**557 S Van Dorn Street
Development
Special Use Permit
#2004-0032**

**Department of Planning and Zoning
Planning Commission Meeting
November 1, 2005**

Docket Item #8
DEVELOPMENT SPECIAL USE PERMIT #2004-0032
COMMERCE BANK

ISSUE: Consideration of a request for a development special use permit, with site plan, for the construction of a free-standing bank building with a four lane drive-through facility.

Site Plan of Proposed Commerce Bank

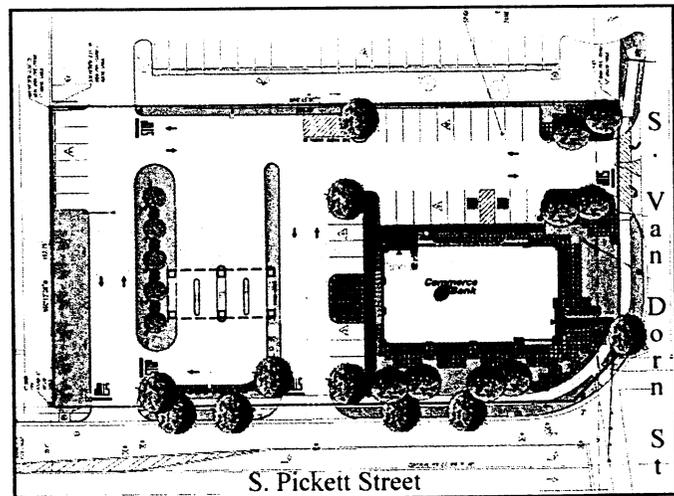
Vehicular access to the site is from an entrance on South Van Dorn Street, which provides access to the building and the parking plus two driveways onto South Pickett Street which provides access to the drive through facility and to a through driveway connecting the parking lot to the Red Lobster parking lot to the north. The South Van Dorn Street driveway is limited to right in and right out turning movements only, while the two Pickett Street driveways will allow all access movements.

The building has been sited and designed to improve the orientation to the street, and eliminate the present site configuration of a building surrounded by an asphalt parking area. The streetscape had been enhanced with improved pedestrian access and additional landscaping and street trees. Staff is recommending specific conditions regarding the streetscape, landscaping and street trees,

Applicant Proposed Pickett St Building Elevation

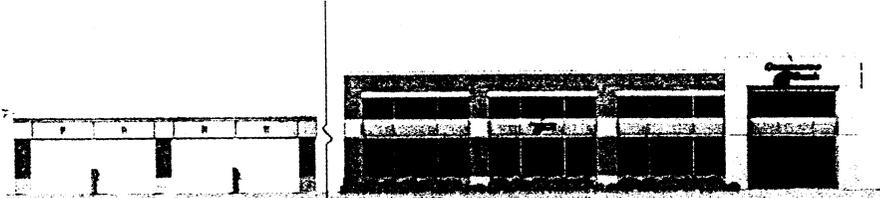
Staff has worked extensively with the applicant to make changes to the original proposed design, and successfully effected the following changes:

- ▶ The applicant agreed to move the building from the center of the site to the southeast corner of the parcel, bringing the building mass and presence closer to and aligned with the street. Parking, originally designed to surround the building, has been relocated to the rear and north side of the building away from the streetscape and pedestrian experience along the streets. Despite efforts to do so, the building could not be moved any closer to the South Pickett Street frontage due to the presence of a recorded setback covenant that was imposed as part of the original subdivision.

- ▶ The primary building entrance was moved to South Van Dorn Street close to the street corner so the building is orientated to the public right-of-way.

- ▶ The original overall building design, more suited to a suburban location than to the City of Alexandria urban building forms has been changed. Materials will now include masonry, pre-cast, and metal panels along with an appropriate level of window glazing.

- ▶ The building design now includes high quality materials, such as masonry and precast elements, in addition to a balance of glazing.
- ▶ Limits on signage to reflect materials and scale that is compatible with what would be appropriate for this area in the future are being imposed.

In addition, staff has proposed further refinements to the design as a condition of approval to occur prior to the release of the Final Site Plan. These proposed refinements will enhance and define the corner element, create a building base, break up the roofline, and add metal canopies to the entrances.

1. The design of the buildings shall be generally consistent with the preliminary building elevations dated August 31, 2005 and shall be revised to provide the following to the satisfaction of the Director of Planning and Zoning:

- a. The building shall be revised to incorporate the following:
 - i. A more prominent corner element.
 - ii. Precast or brick base.
 - iii. Vertical pilasters projecting above the roofline.

- iv. Prominent entry metal canopy for the corner and northern entrance.
 - b. The facade materials of the entire building and the drive-thru structure, shall be masonry (brick, precast, stone) or metal, including lintels and sills.

Original Site Layout

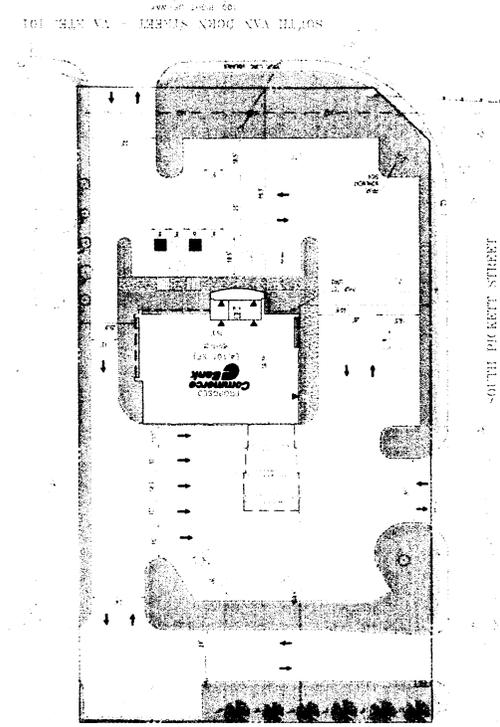
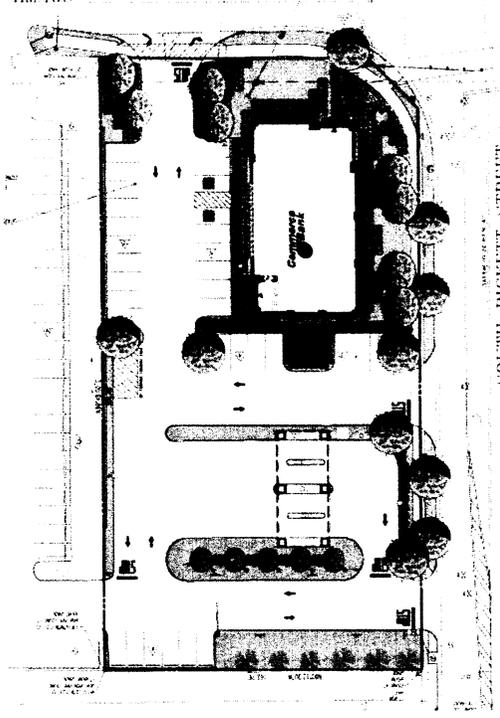
- **Compatibility with Upcoming Landmark/
Van Dorn Plan**
- **Site Plan**

- **Buildings up to the street**
- **Parking to the side or rear**
- **25 to 30 foot setback on Van Dorn St for streetscape**
- **Van Dorn Street as more of an “Urban Boulevard”**
